BAR Meeting
June 19, 2013

ISSUE: Permit to Demolish/Capsulate and Addition/Alterations

LOCATION: 217 South Fairfax Street

BAR2013-00169 & BAR2013-00170

SHEET
CSI

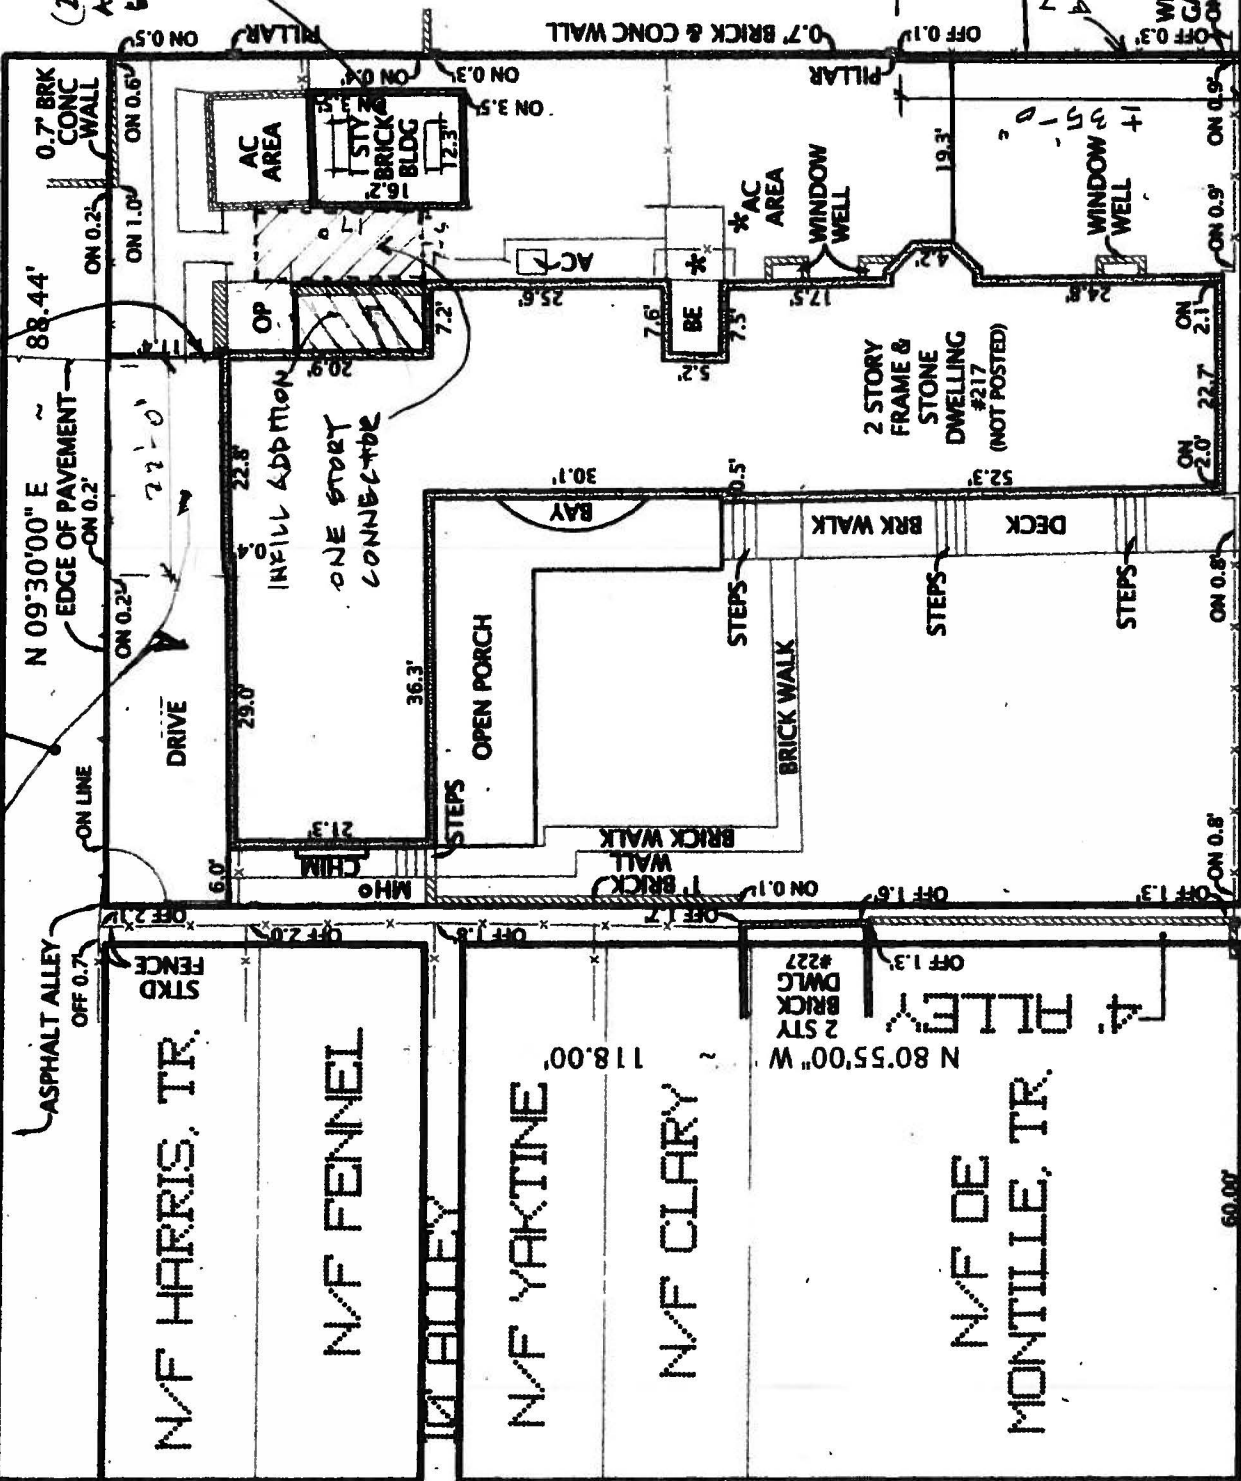
Staff is concerned about the at-grade one-story addition which will link the existing residence to the historic outbuilding. While the existing south wall will be capsulated and not demolished, the addition of this connector significantly compromises the historic integrity of the freestanding structure and further enlarges the footprint of this significant house. Outbuildings play a significant role in the history of Old Town, as they add a visible layer to the history of neighborhood development. Staff recommends denial of this portion of the application. Staff could support a simple trellis connecting the two features.

Staff has no objection to the installation of two low-profile skylights on the south slope of the outbuilding roof. An inspection of the outbuilding reveals that what was once likely a utilitarian building has had a number of repairs over the years, the building has relatively new roof rafters and the building has been dry walled. The roof is relatively new. The loss of historic fabric on the roof is minimal and visibility of the skylights will be extremely minimal.

Staff supports the applicant's proposal to extend the 6' brick wall on the north property line an additional 35' to the front property line. In addition, Staff finds the relocation of the rear fence acceptable.

The increased height of the front property line fence is more problematic. As the BAR is aware, the Board has the ability to waive the front yard fence height "where the board finds that a proposed fence would be architecturally appropriate and consistent with the character of the district." Staff is somewhat reluctant to recommend approval of the height increase given that the public's ability to see and appreciate the open space was a representation made by a prior owner when requesting Board approval of the rear addition in 1992. In addition, the Board clearly articulated the historic solid/void relationship of buildings and open space on the west side of this block during the recent denial of a proposed garage at 207 South Fairfax Street. A tall, solid fence would diminish the rhythm of these open spaces on this block face. However, because the 50% open wood picket fence will remain atop the new brick retaining wall, Staff supports the minor height increase. Furthermore, the 6' fence will still be approximately one foot lower than the adjacent brick wall at 227 South Fairfax Street.

3. Denial of the at-grade infill addition between the house and the outbuilding; and
4. The following archaeology conditions shall appear in the General Notes of all site plans and on all site plan sheets that involve demolition or ground disturbance (including Basement/Foundation Plans, Demolition, Erosion and Sediment Control, Grading, Landscaping, Utilities, and Sheeting and Shoring) so that on-site contractors are aware of the requirements.
